# Umetco Minerals Corporation

Subject: Umetco Minerals Corporation Gas Hills, Wyoming, Groundwater Evaluation  
Reference: Materials License SUA-648; Docket No. 40-0299

**TO:** Umetco Minerals Corporation  
**FROM:** URS Corporation  
**DATE:** May 2012  
**SUBJECT:** Gas Hills Groundwater Model and Data Review

Figure 2b Simulated Chloride Trends at MW28 (50 Years) Versus Actual Data  
Western Flow Regime

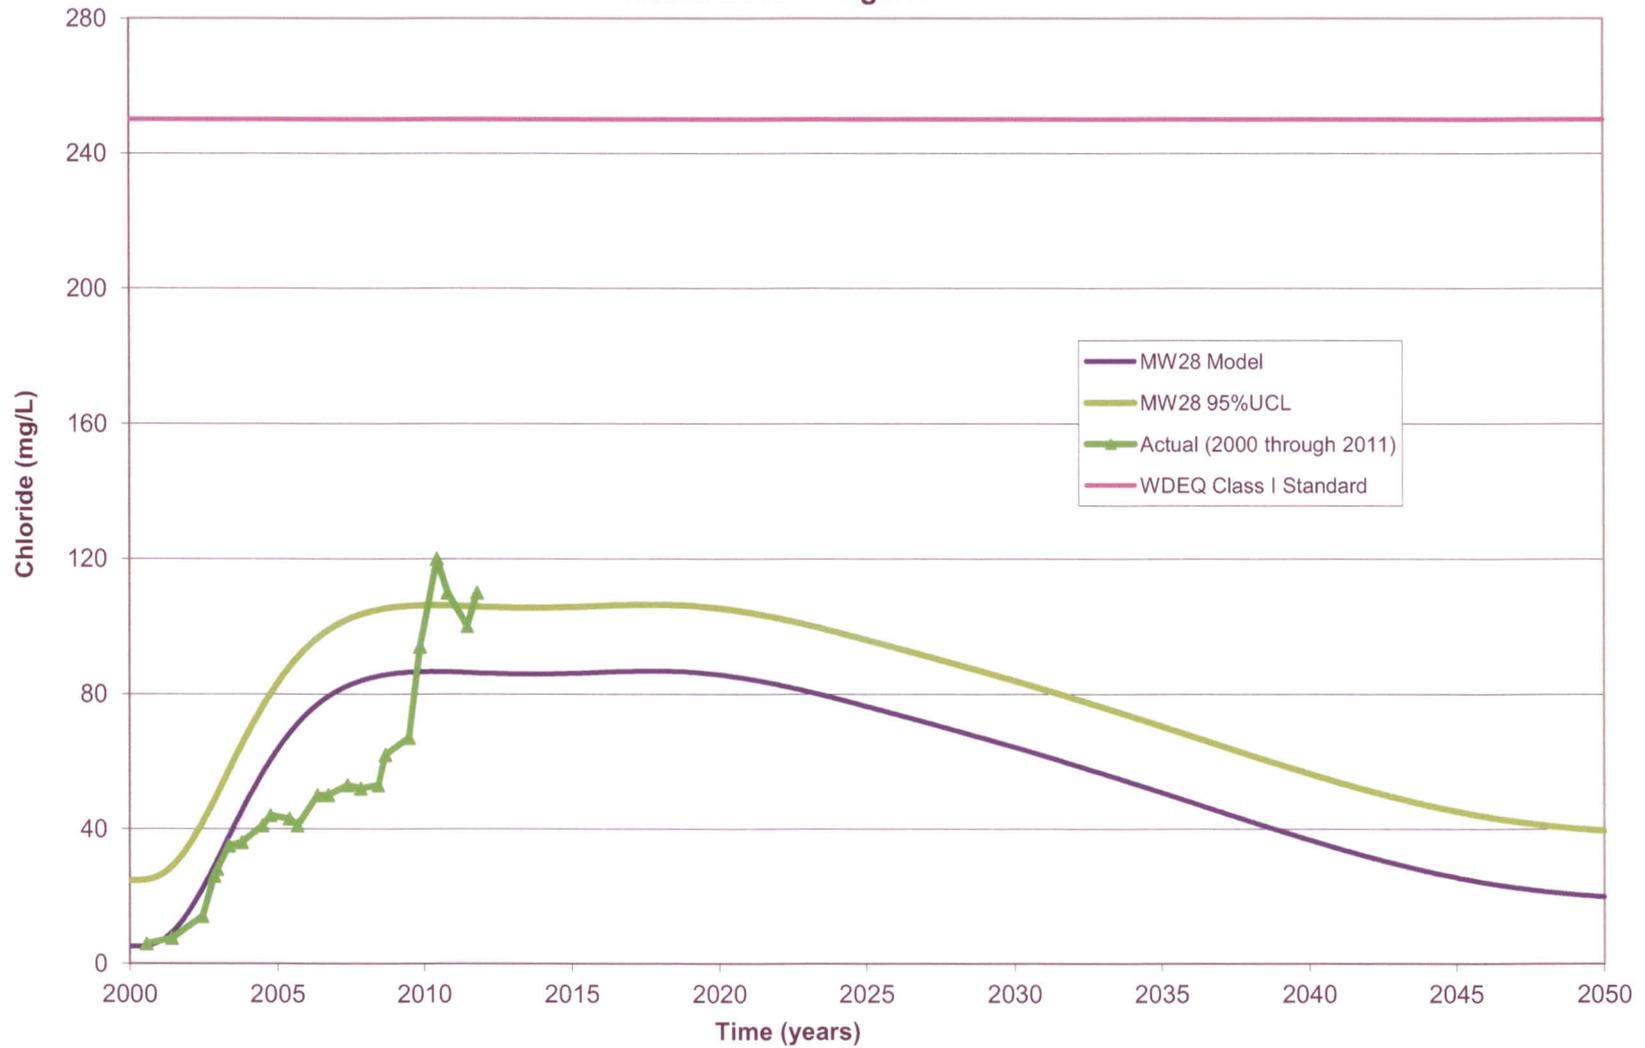
With respect to well MW 28, chloride and sulfate concentrations have increased upward, as predicted, and appear to be trending near the 95% UCL. However, these concentrations are several times less than concentrations associated with upgradient well MWI 64, located adjacent to the impoundment, and have shown a sharp decline since 2007. ACL constituent concentrations in the nearby POC well MW 21A have remained low and stable with no increase to trends. Accordingly, the chloride and sulfate trend in MW 28 indicate elevated concentrations of these constituents have arrived, as predicted, and are in reasonable agreement with predicted concentrations which are far less than Wyoming Department of Environmental Quality WDEQ Class III standard for sulfate and Class I standard for chloride applicable at the POE. Considering the sharp reduction in chloride and sulfate concentrations at the upgradient well MWI 64, there is no indication that concentrations in MW 28 will not trend downward as predicted.

As shown in Attachment A (Figures 2b and 6b), monitoring well MW28 is the “model validation” well where chloride and sulfate concentrations exceeded the model-predicted trends and the 95 percent UCL in 2010 and 2011. Considering the concentration trends observed at other surrounding wells in the WFR, the recent increasing constituent concentration at MW28 is expected as the result of constituent plume movement as predicted by the model. The recent constituent concentration increase at monitor well MW28 may correspond to the recent decreasing concentration trend observed at monitoring well MWI64 since 2007. This indicates that the constituent plume is moving from the source area to the downgradient area as a slug plume. It is expected that the concentration trend at well MW28 will change in the future from increasing to decreasing similar to the observations at well MWI64.

Figure 3b Simulated Chloride Trends at MW72 (50 Years) Versus Actual Data  
Southwestern Flow Regime

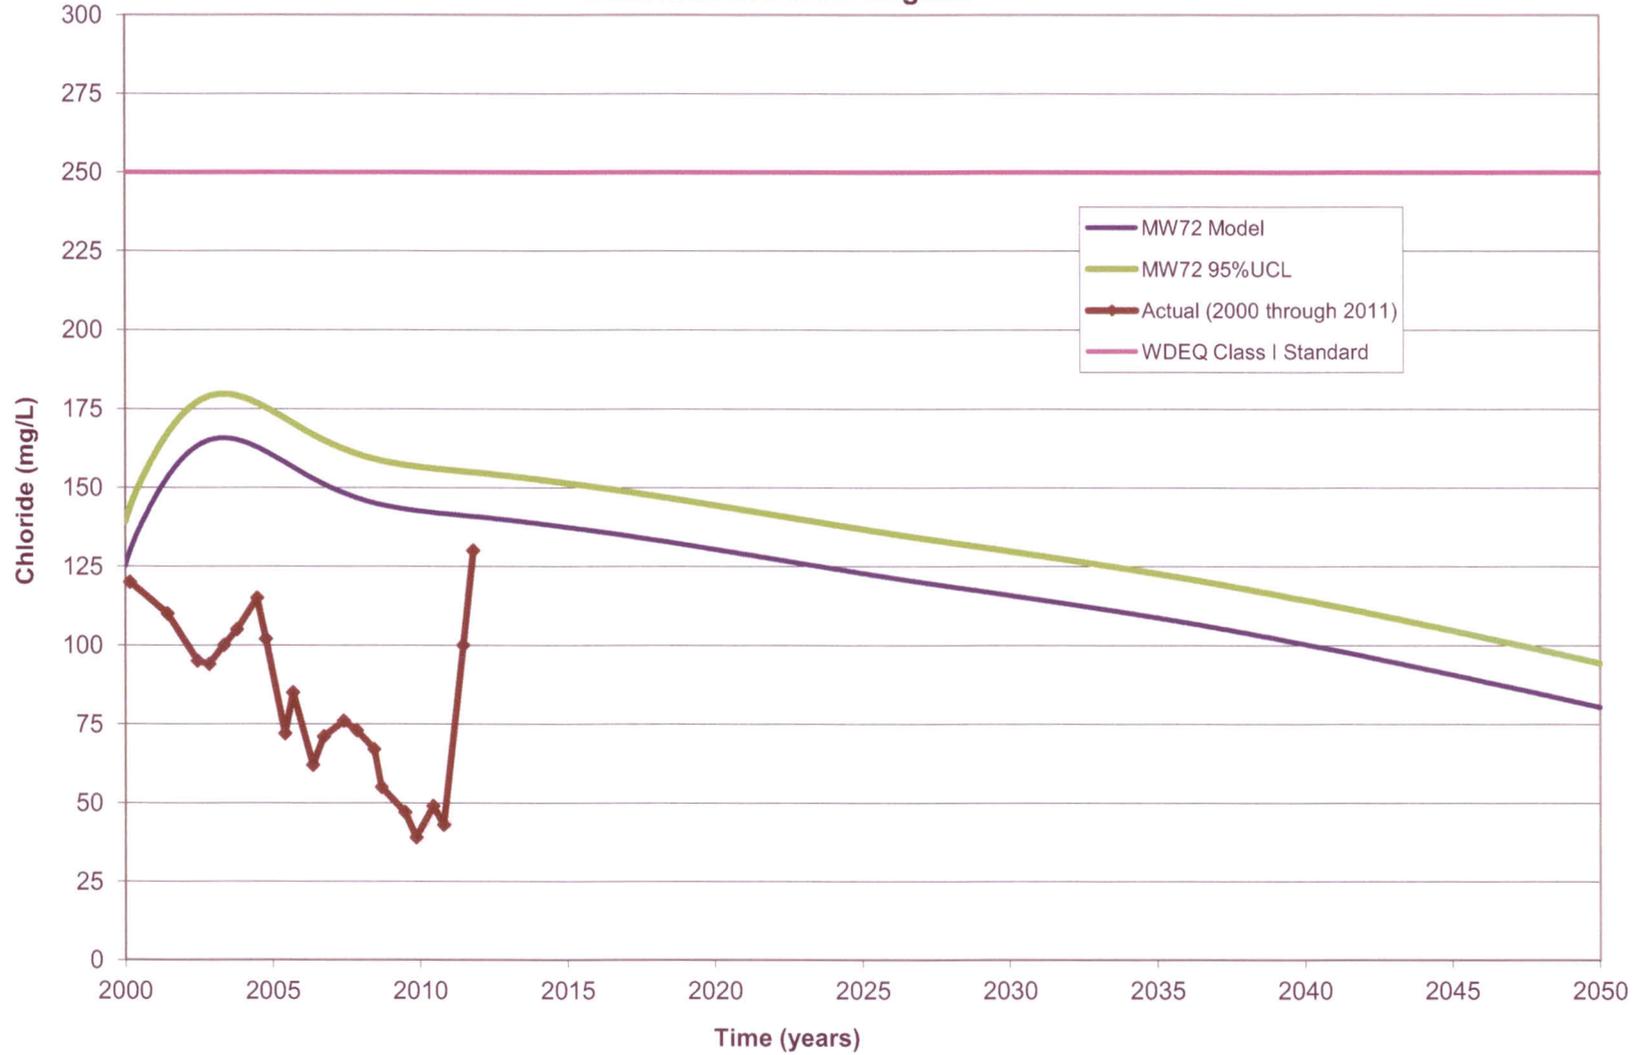
As shown in Attachment A, the recent increasing chloride and sulfate concentration trends at monitoring well MW72 (Figures 3b and 7b) differ from the model predicted trends. The exact reasons for the water level fluctuation, the decreasing concentration trends prior to 2010, and the concentration increase in 2011 at MW72 are not clear. It is likely that the conditions at MW72 are influenced by variations in the upgradient area and related to the local hydrogeologic and geochemical conditions. Overall, the degree of concentration variability at well MW72 is greater than what the model can predict, but is still within an acceptable level of model uncertainty.
